Southern Nuclear  
Operating Company, Inc.  
42 Inverness Center Parkway  
Birmingham, AL 35242

Southern Nuclear Operating Company  
Vogtle Electric Generating Plant Units 3 and 4  
Request for License Amendment and Exemption:  
Debris Screen Related Dimensions (LAR-16-013)

**Debris Screen Related Dimensions**

**(LAR-16-013)**

**Figure 1, Above Screen Location (Front View)**

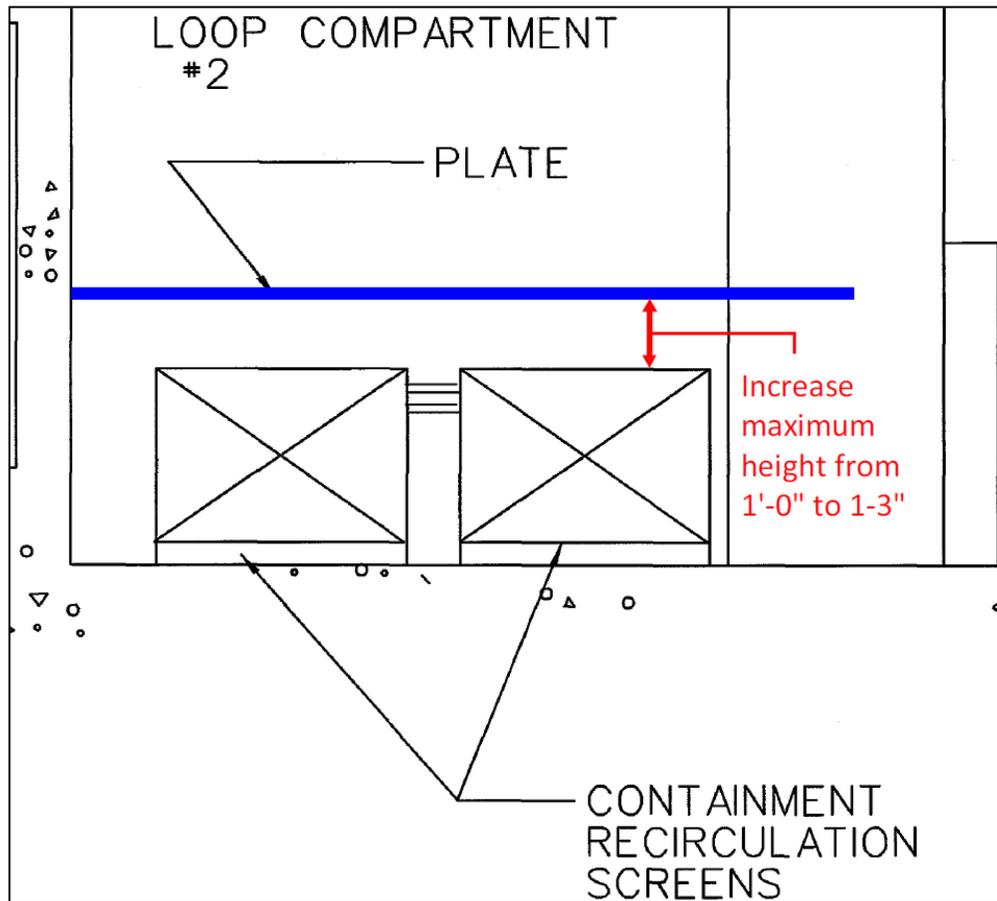
This proposed change alters the location and dimensions of this plate. Plant-specific Tier 1 Table 2.2.3-4, along with the supporting UFSAR information, identifies several dimensional requirements for the protective plate to enable settlement of debris falling into the CR flow path to prevent it from reaching the screens. The associated plant-specific Tier 1 requirements include the requirements that the plate (1) be located no more than 1 ft above the top of the containment recirculation screens, (2) extend out at least 10 ft perpendicular to the screen surface, and (3) extend at least 7 ft to the side of the screen surface. During a review of the plant design, it was identified that the proposed construction alternatives for the plate did not meet Tier 1 ITAAC requirements (1) and (2) identified above.

To address this inconsistency, it is proposed that the maximum distance of the plate above the top of the screen be increased to a height of 1 ft 3 in as shown in Figure 1 below. Note that this height requirement applies only at the required distances perpendicular to and to the side of the screens, as the corresponding debris transport evaluation, discussed further below, credits the height of the plate at these locations only. Changes are proposed to UFSAR subsection 6.3.2.2.7.1 to clarify this requirement. As discussed below in the technical evaluation that assesses the effect of this change on debris transport, this increased spacing does not adversely affect the design function of the protective plate, and thus continues to support acceptable screen performance.

**Figure 2, Plate Extension Length (Top View)**

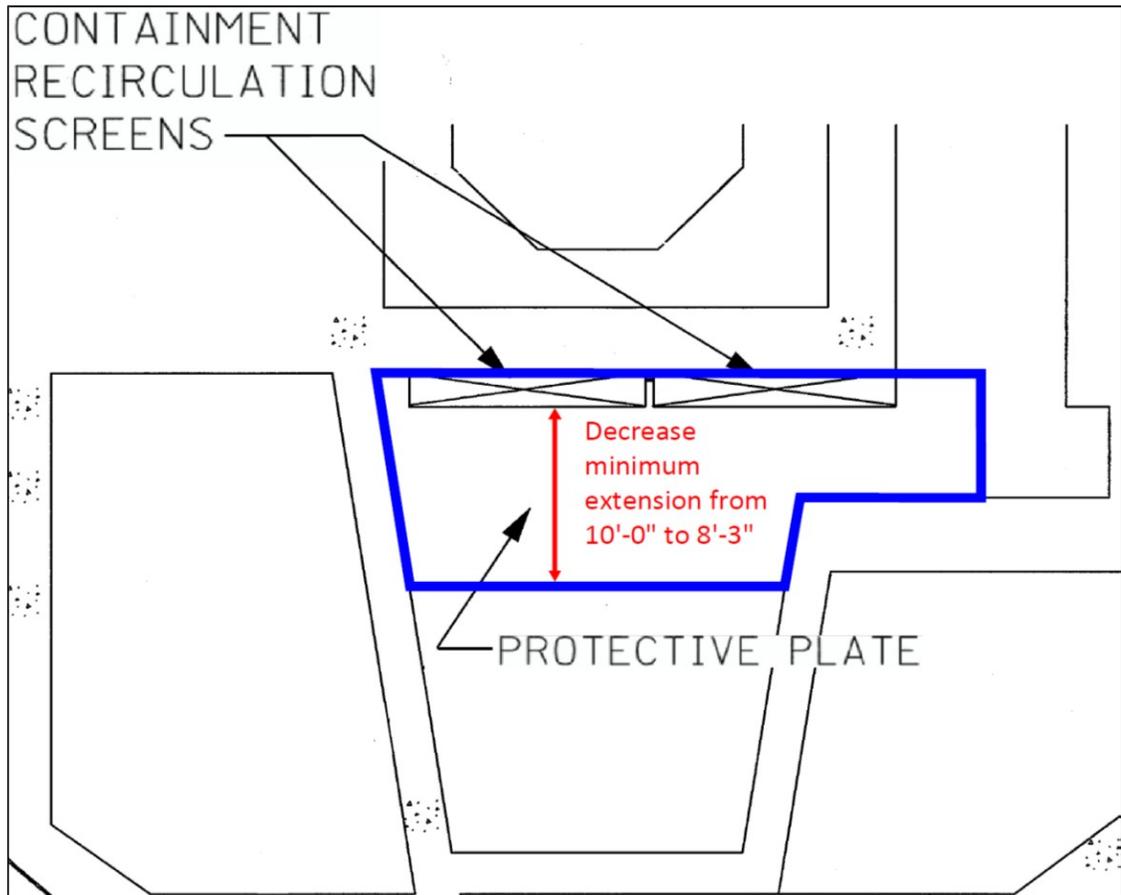
Additionally, it is proposed that the perpendicular extension of the plate beyond the recirculation screens be reduced from 10 feet to 8 feet, 3 inches as shown in Figure 2 below. This reduction increases clearance to support reactor coolant pump (RCP) removal and increases the accessibility for future maintenance. The proposed dimension changes affect COL Appendix C, plant-specific Tier 1, and the UFSAR identified minimum plate extension length from the front of the CR screens. The necessary licensing basis document changes are described in Table 3 below. As discussed below in the technical evaluation that assesses the effect of the change on debris transport, this reduction in plate length does not adversely affect the design function of the protective plate, and thus continues to support acceptable screen performance.
